## SCSI Single-ended Termination for SPI-2

X3T10/96-245R1

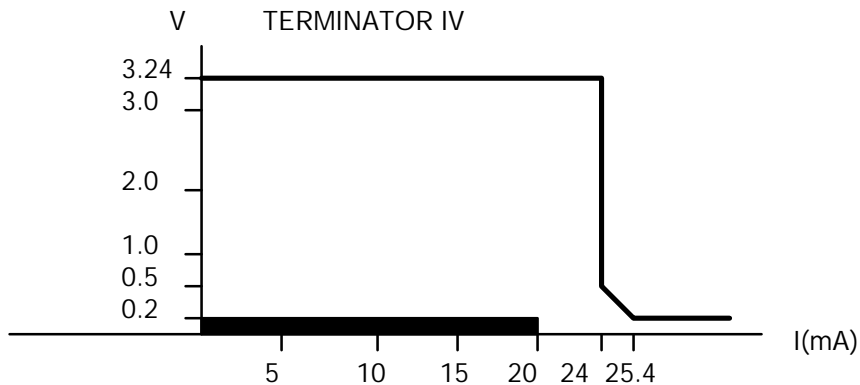
The proposal is for a modification of the SPI output current below 0.5V to accommodate 25.4mA at 0.2V. The goal is to make SCSI-2 and SPI alt-2 terminators compatible without changing anything else. The graph for the IV curve is:

The graph shows the allowed area of operation for the single ended terminator. The solid black line shows the maximum allowed termination current. The key points are;

- The maximum current at 0.2V is **25.4mA**.
- The maximum current at any voltage greater than or equal to 0.5V is **24mA** (which is the current SPI limit).
- The region below 0.2V is left open for undershoot clamps and the maximum current is not specified.
- The solid box below the 20mA region (@0.2V) can be included for the specific reason of disallowing the 220/330 terminator as is done in SPI.
- The terminator should not source current whenever the terminal voltage is greater than 3.24V.
- The terminator shall source current to the line when the terminal voltage is below 2.5V dc.
- The terminator open circuit voltage should be at least 2.5V.
-

The region to the left of the center axis is left open for termination sink current. This change to the IV curve would make the SCSI-2 alt-2 terminator and the SPI terminator compatible without affecting or adding to any of the other existing terminator specifications.
